ADDENDUM #1

PLANS - DEMOLITION, FLOOR, REFL. CLG., AND BLDG SECTION

BLAIR LEARNING CENTER RECONSTRUCTION

sheet A2.0

DEMOLITION PLAN

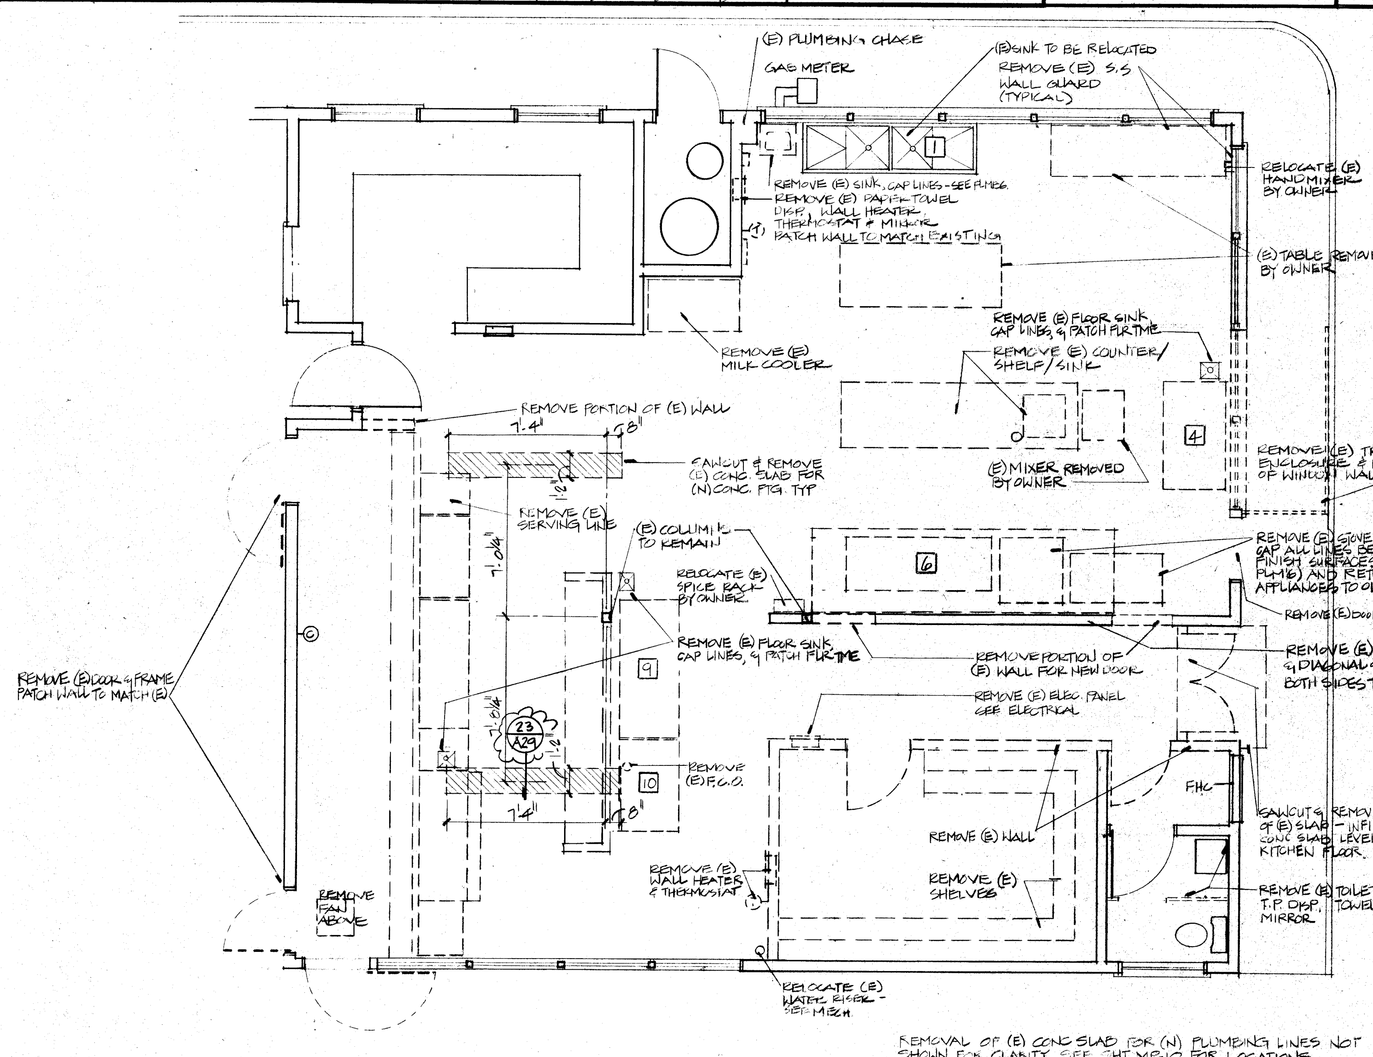
1. ALL EQUIPMENT, TABLES, CABINETS SHOWN TO BE REMOVED SHALL BE RETURNED TO OWNER.
2. REMOVE PORTION OF (E) LIP FOR POT WASHING SINK, REPLACE WITH (N) S.S. PIECE TO TRANSITION TO (N) S.S. COUNTER. WELD ALL CONNECTION POINTS CUT, AND GRIND SMOOTH.
3. REMOVE ALL (E) FLOORING AND T.S.B AND PREPARE SURFACE FOR (N) SHT. VINYL FLOORING - TYP FOR ALL ROOMS SHOWN. NOTE: 6" COVE BASE TYPICAL AT ALL SHT.VNL.
4. VERIFY SIZE OF EQUIP. IF EQUIP DOES NOT FIT IN BETWEEN WALLS W/ ½" CLR. BETWEEN HEAT PROTECTION & EQUIP., NOTIFY ARCHITECT.

FLOOR PLAN
1/4" = 1'-0"

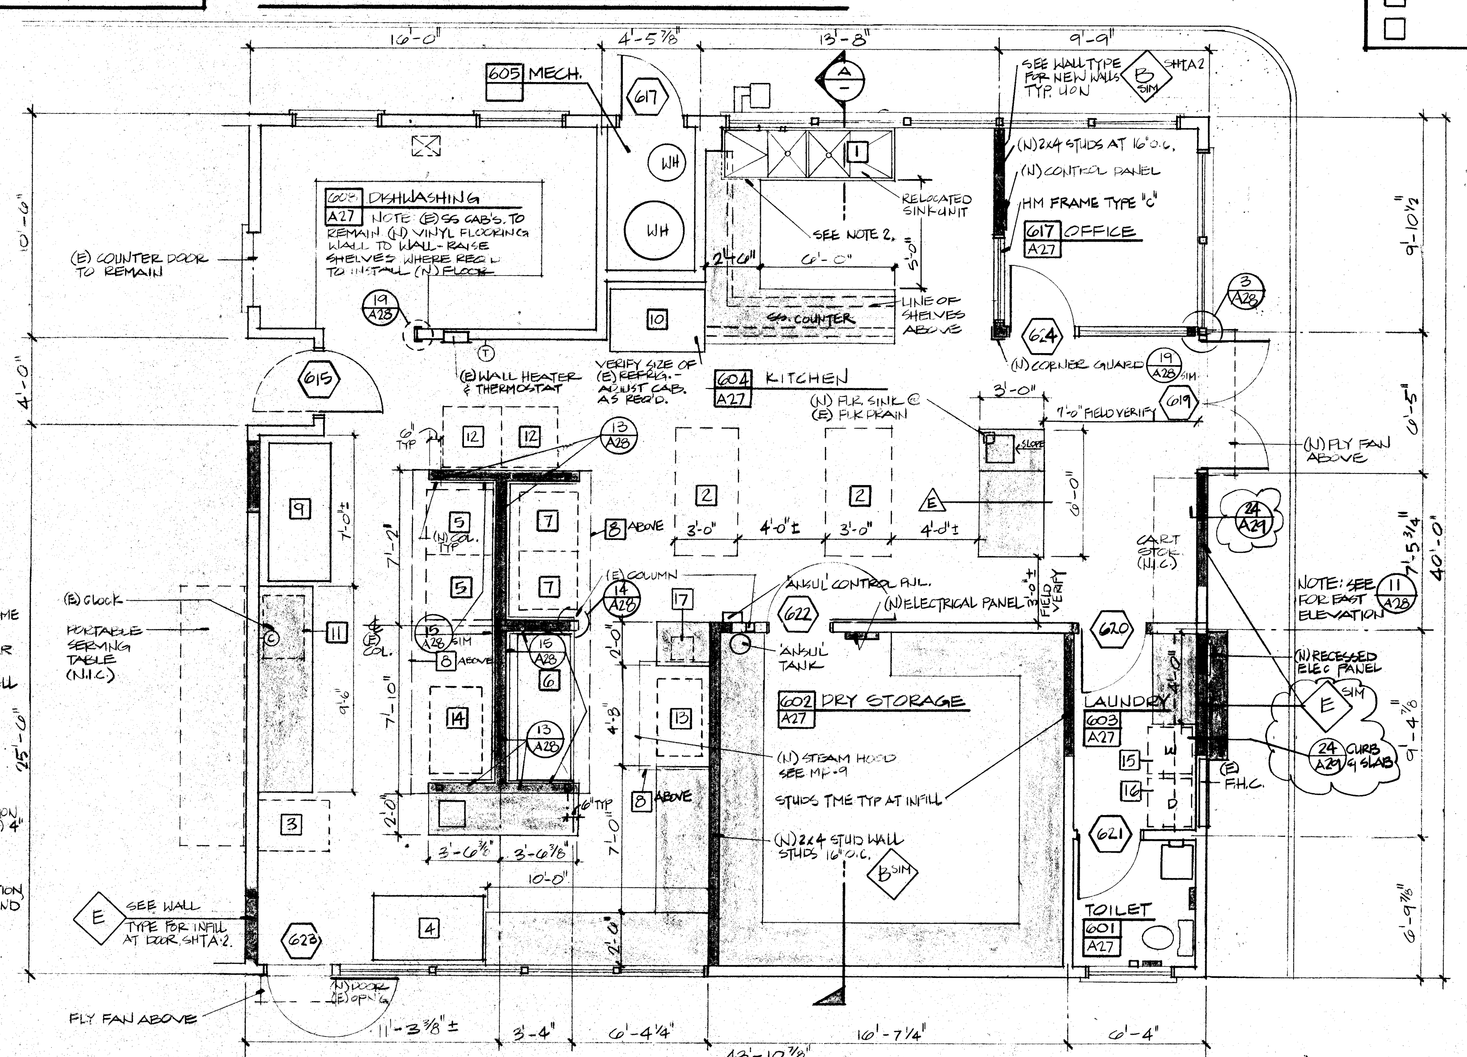
REMOVAL OF (E) CONC SLAB FOR (N) PLUMBING LINES NOT SHOWN FOR CLARITY. SEE SHT MP-10 FOR LOCATIONS. REMOVE SLAB BY SAW CUTTING
